TOPIC: PC 23-004: the Flats & the Lofts of West Village: PUD Site Plan Review

Subject: PC 23-004: The Flats & The Lofts of West Village: PUD Site Plan, Review #2

Re: West Village PUD
Final PUD Review #2 – revised 8/30/23
NFE Job No. M900

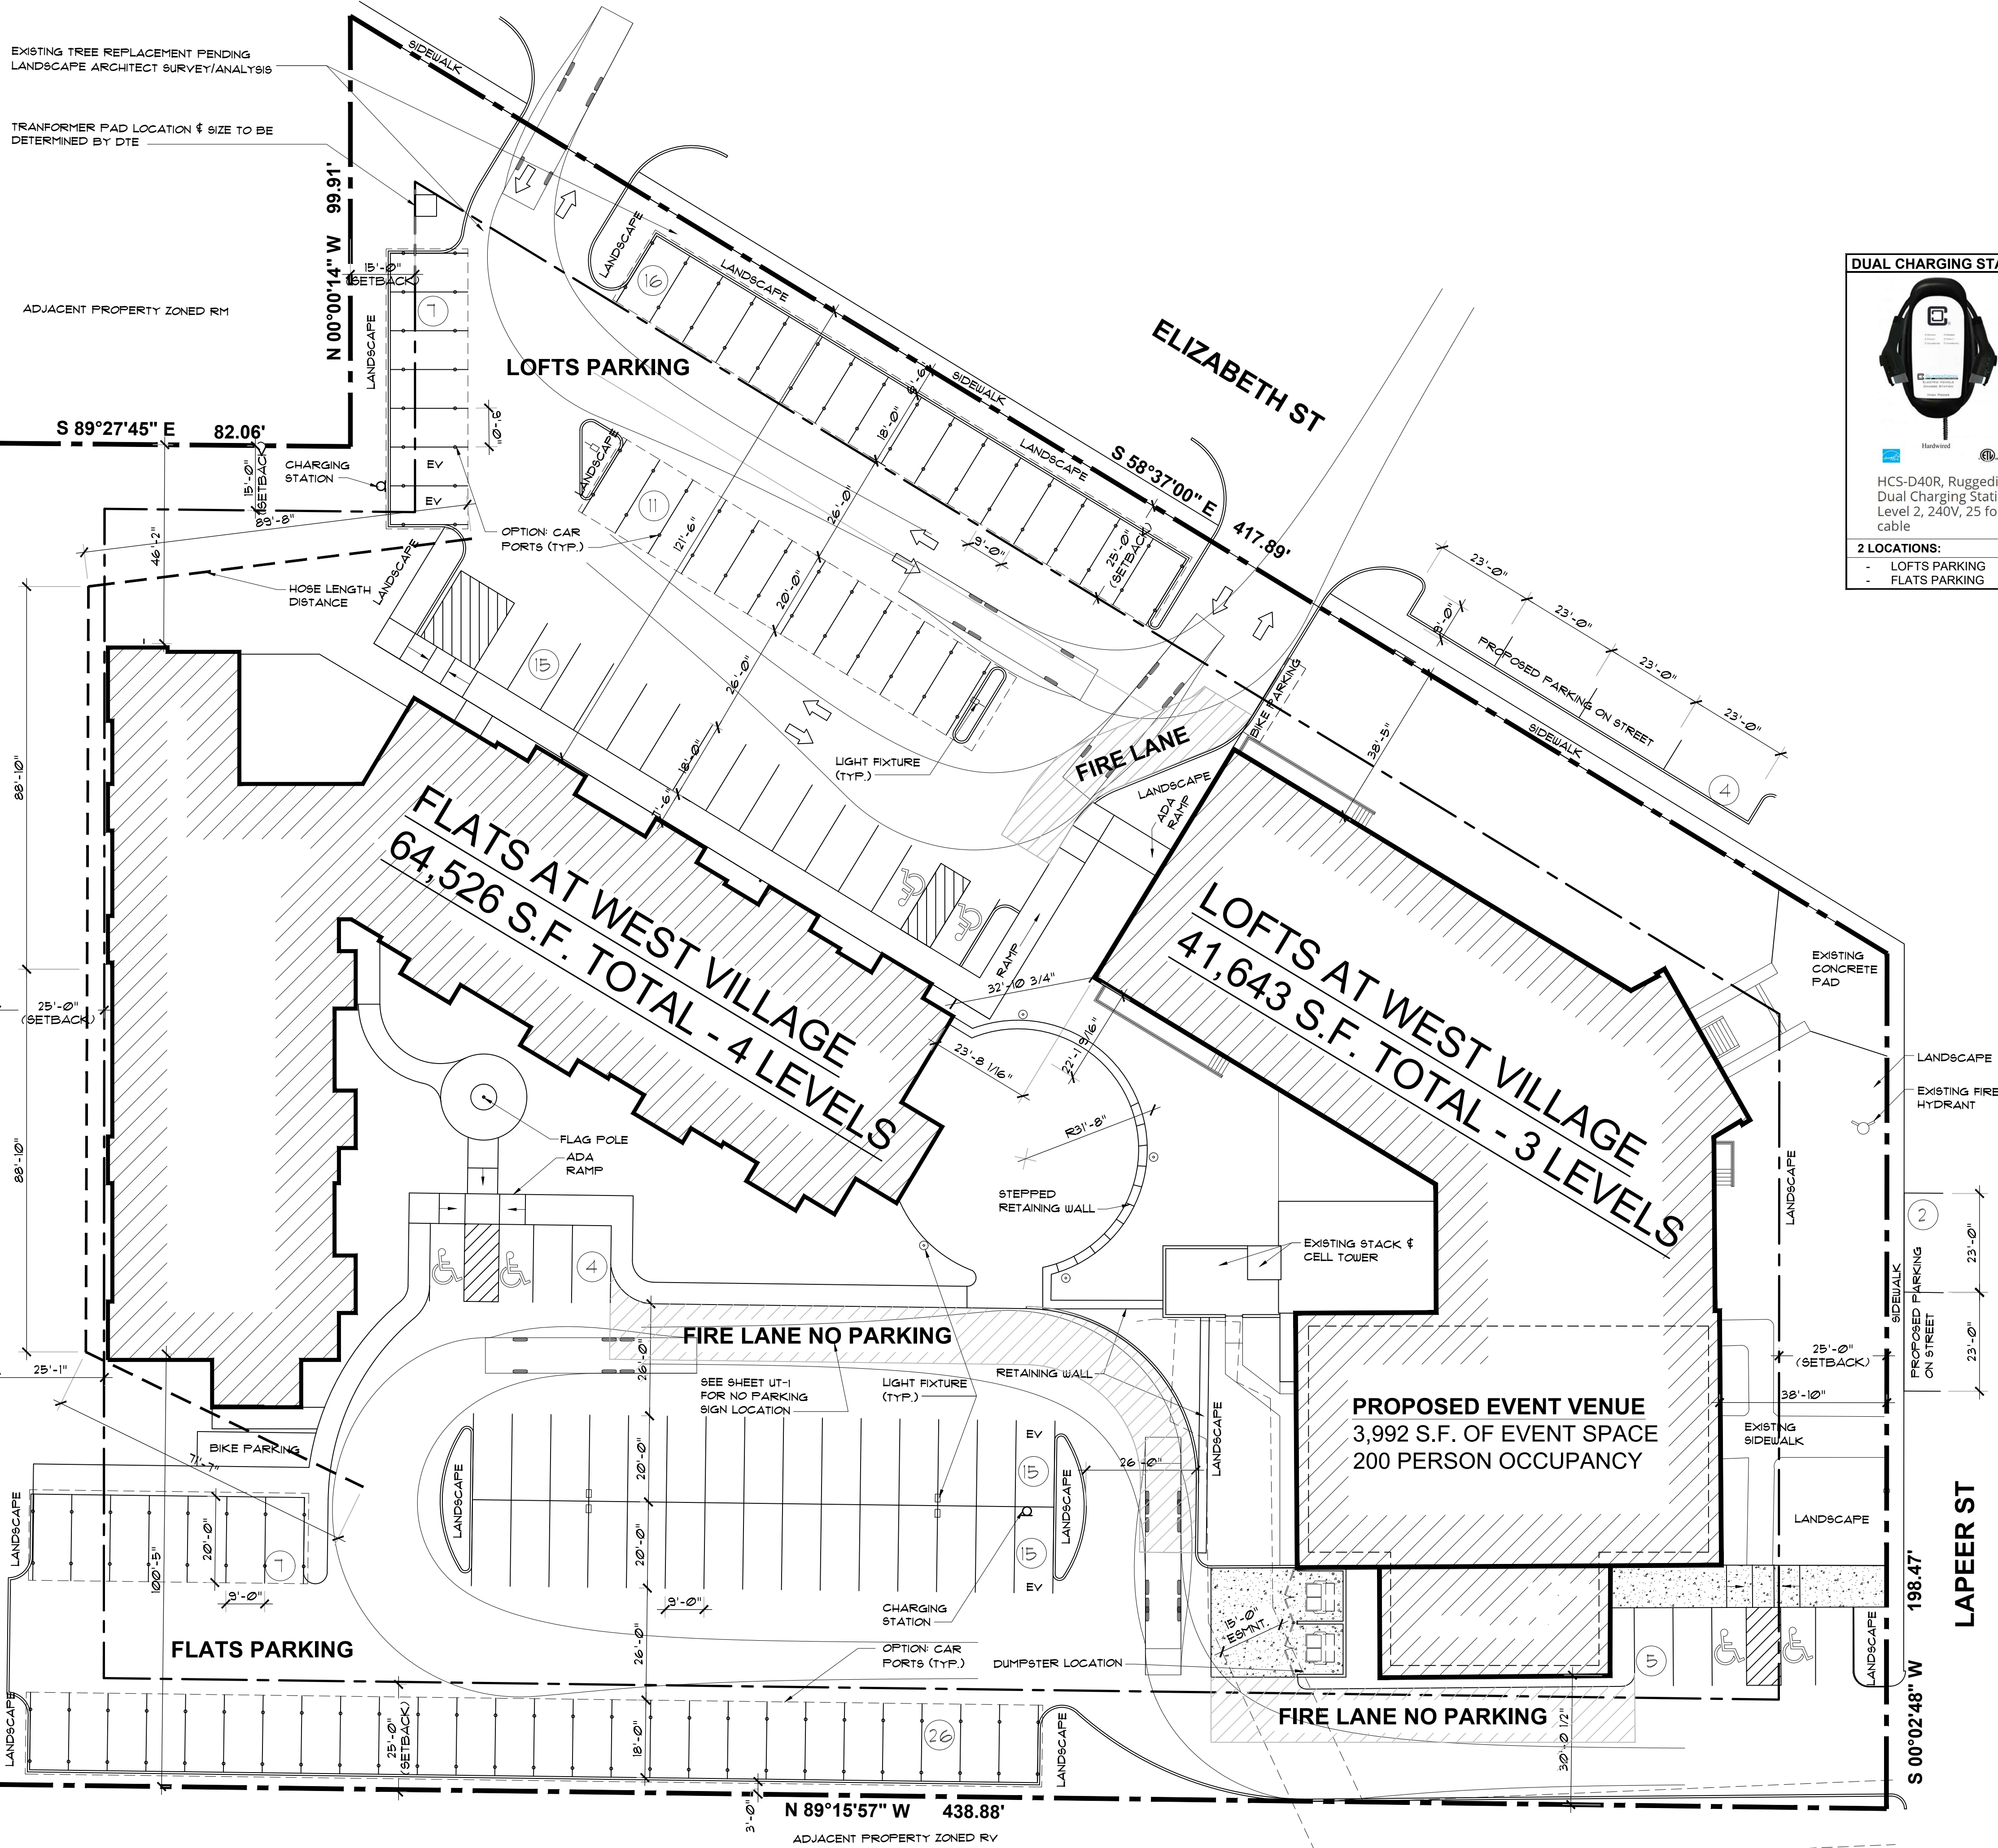
The applicant must consistently show the two on-street parking spaces on Lapeer Street, as sheet SP101 and the photometric plan are the only sheets that depict these spots. These two sheets contradict, as one shows a curb cut and one does not. We recommend the applicant install a curb cut for the two proposed Lapeer parking spaces or provide proposed striping. Further, the applicant must show the location of the additional 14 on-street parking spaces.

7. Sheet SP 101 indicates 2 proposed on-street parking spots on Lapeer Street. These are not shown on the proposed paving and grading plan.
8. The retaining wall as shown on sheet SP 101 has not been revised to follow the back of curb as shown on the civil plans and as indicated in the response letter.

9. The 5 parking spots at the southeast corner of the site are not shown in the table, and the “20 on street” spots cited in the table are not shown on any plan.

SP 102

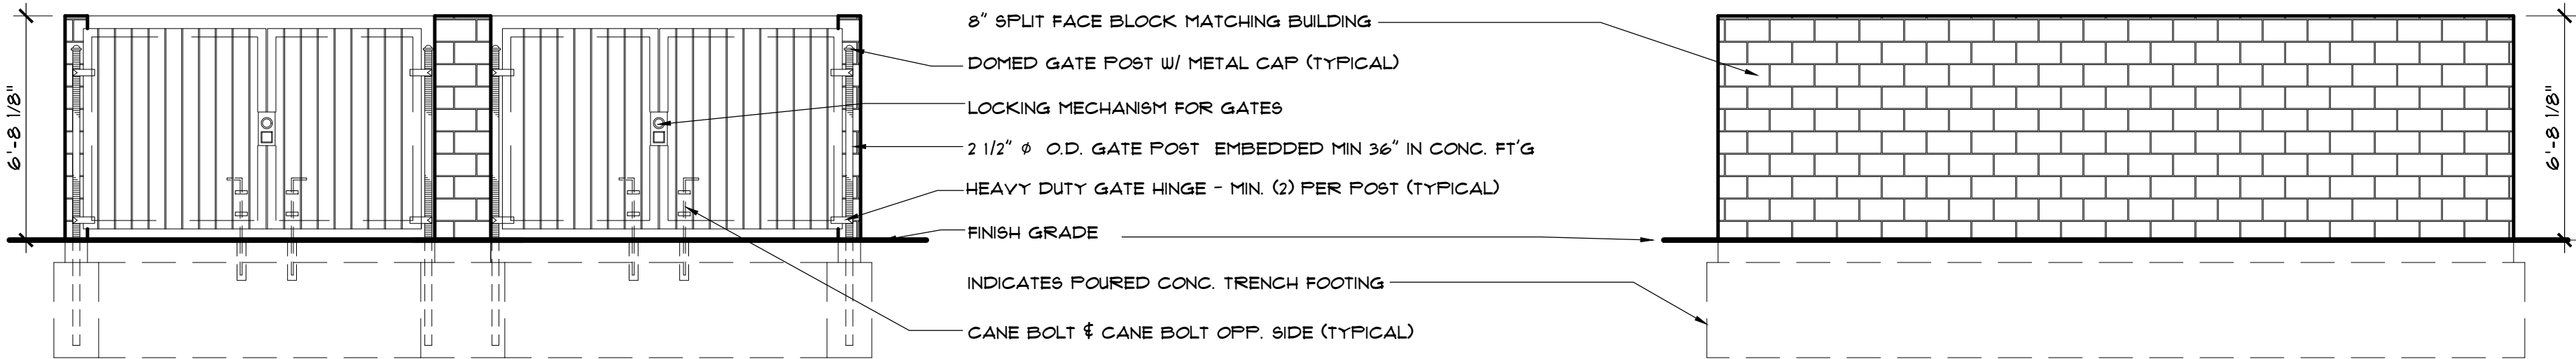
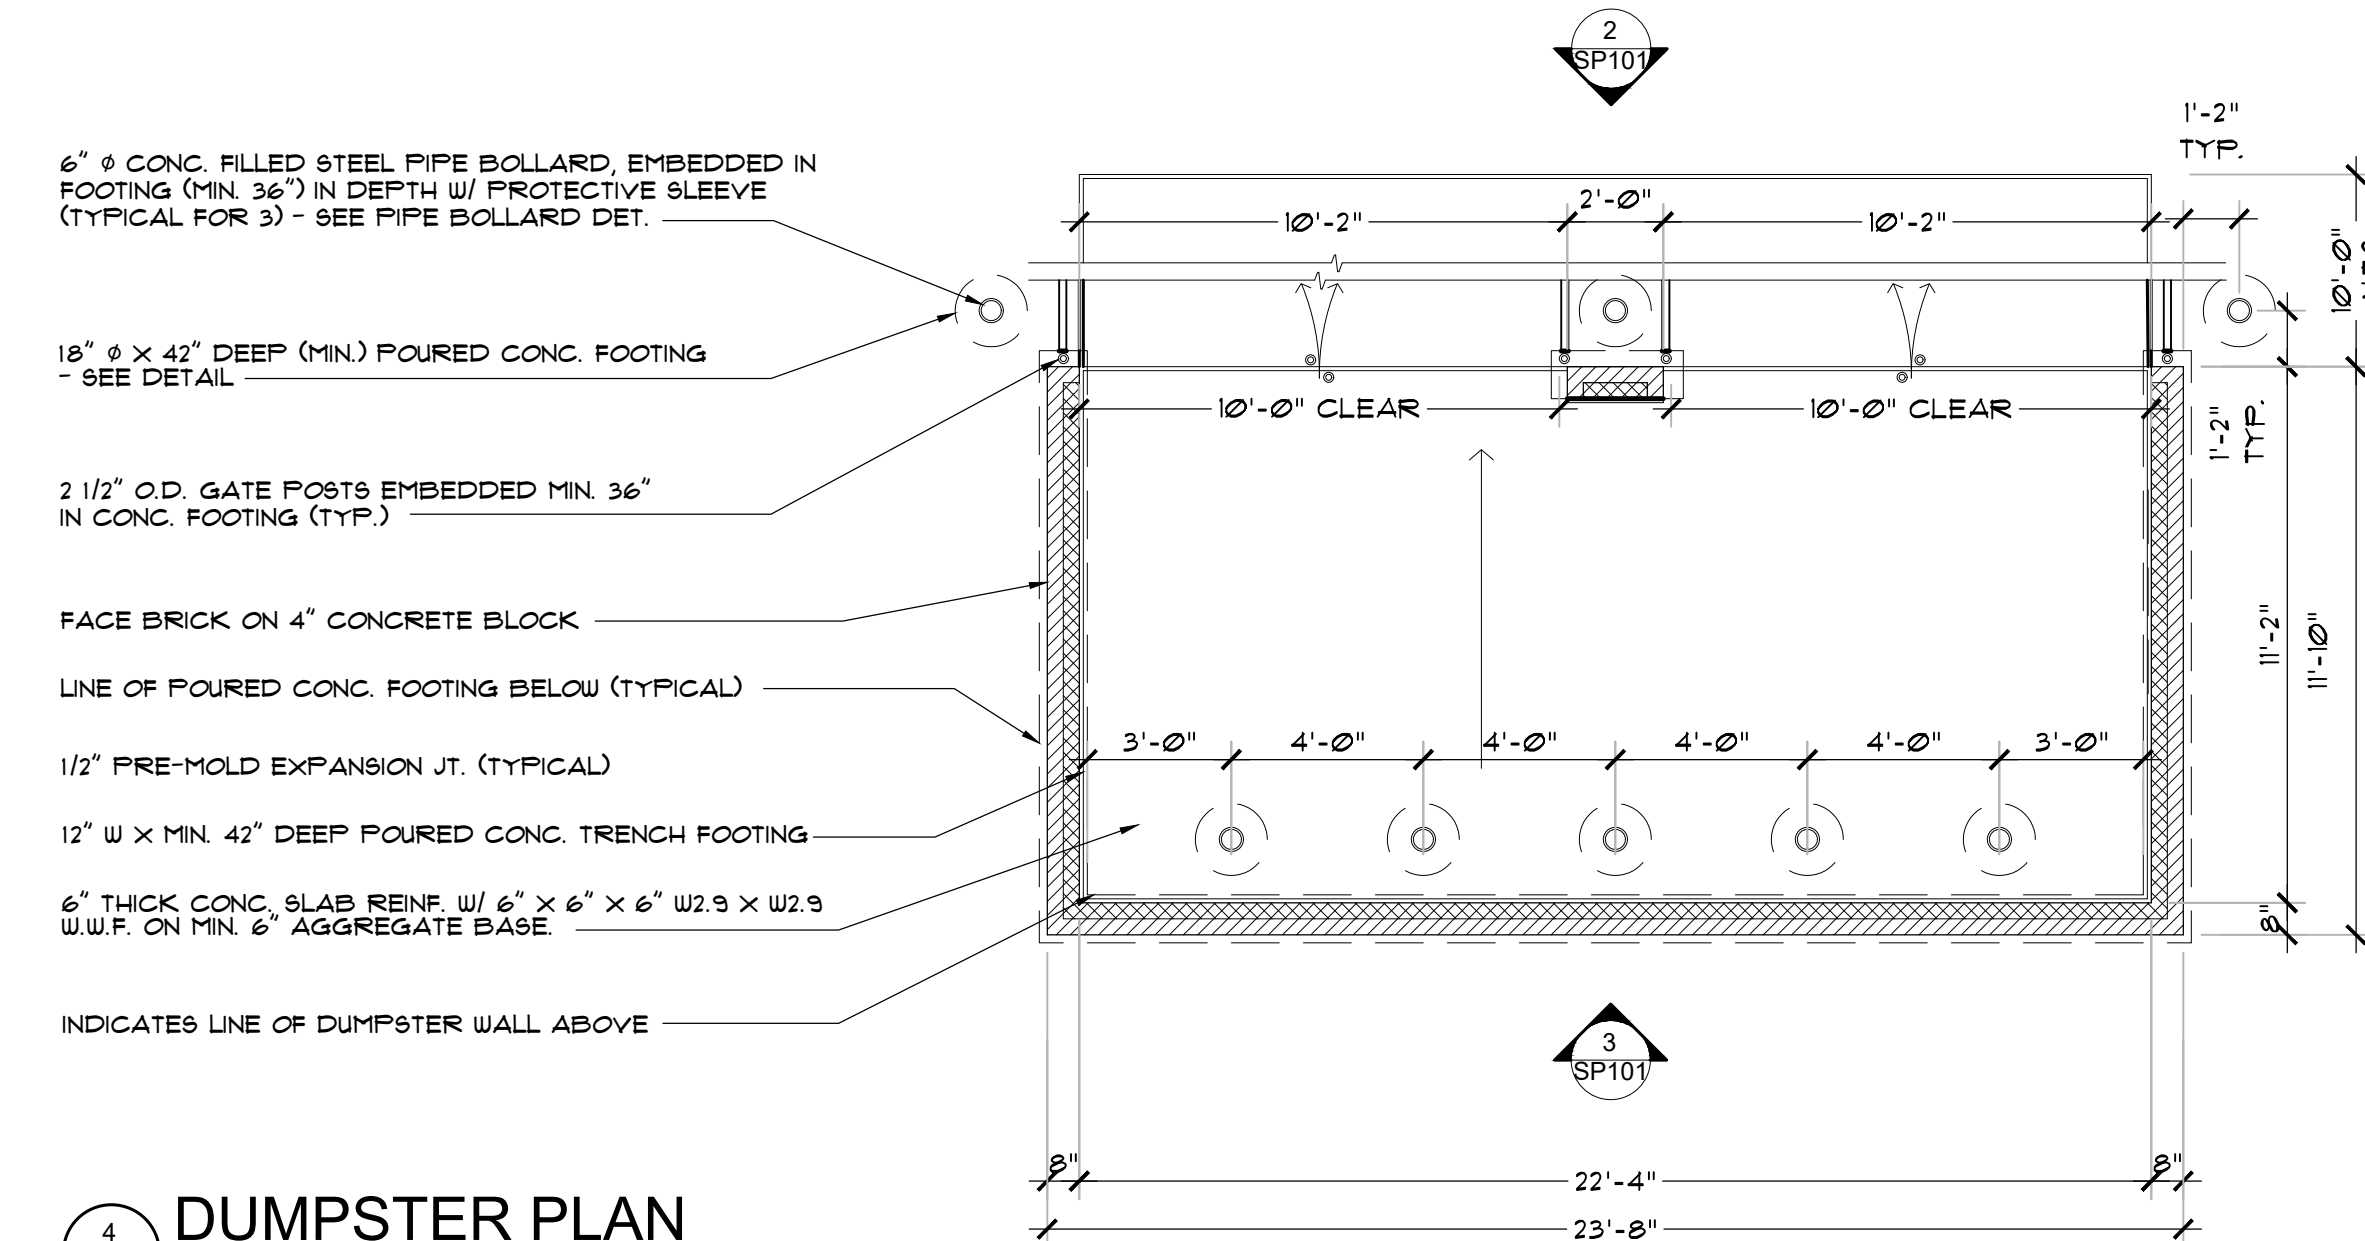
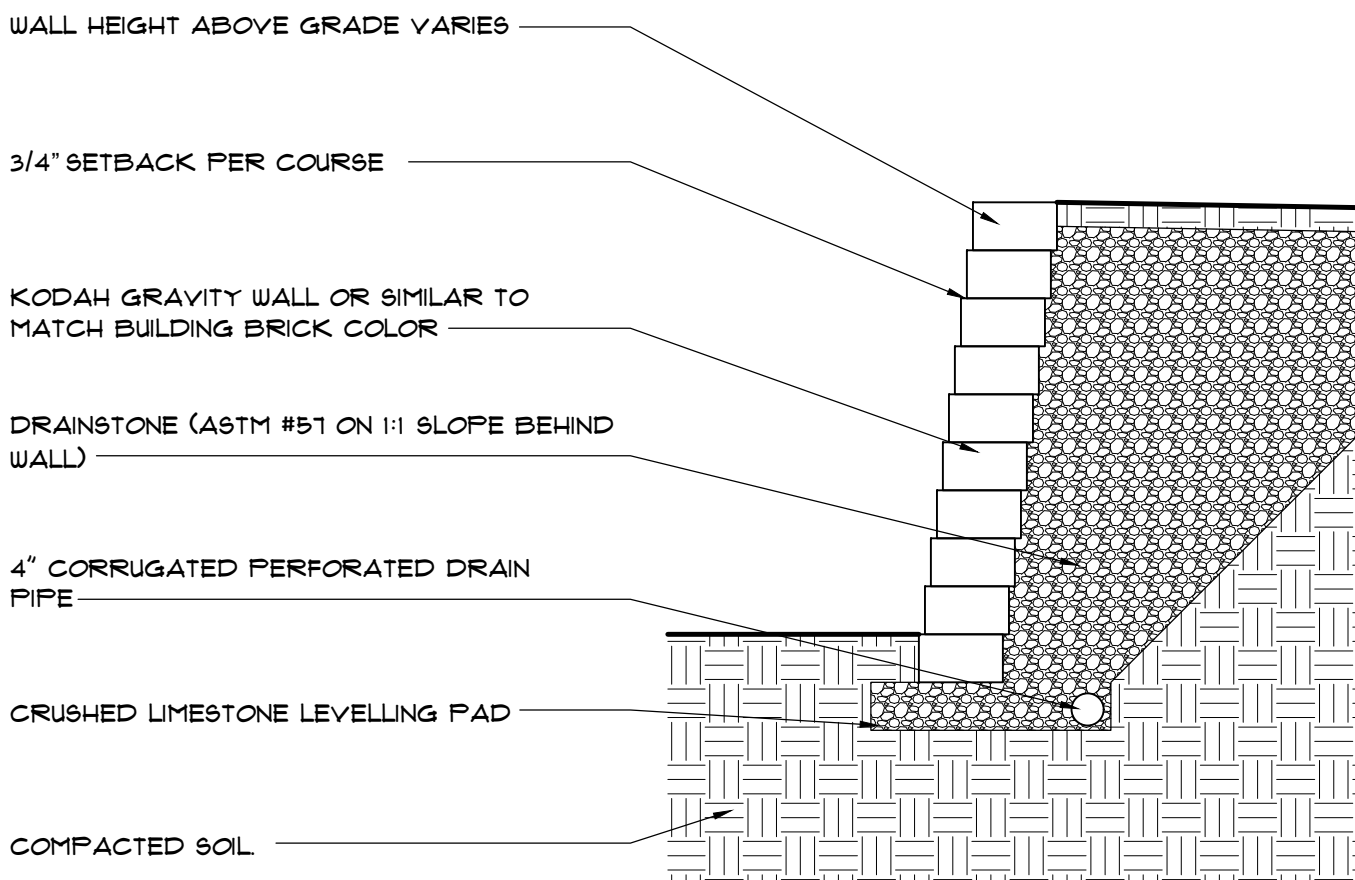
Cross sections and elevations of the proposed dumpster enclosure and retaining wall have been provided. The plans note that the proposed dumpster enclosure will have 8" split-face block that will match the building and the proposed retaining wall will include a Kodah Gravity Wall, similar in color to the brick.

- **Dumpster & retaining wall details updated SP 102.**
9. *Location of the transformer pad and method of screening is required but not shown.*
 - **Transformer pad added to sheet SP 101.**
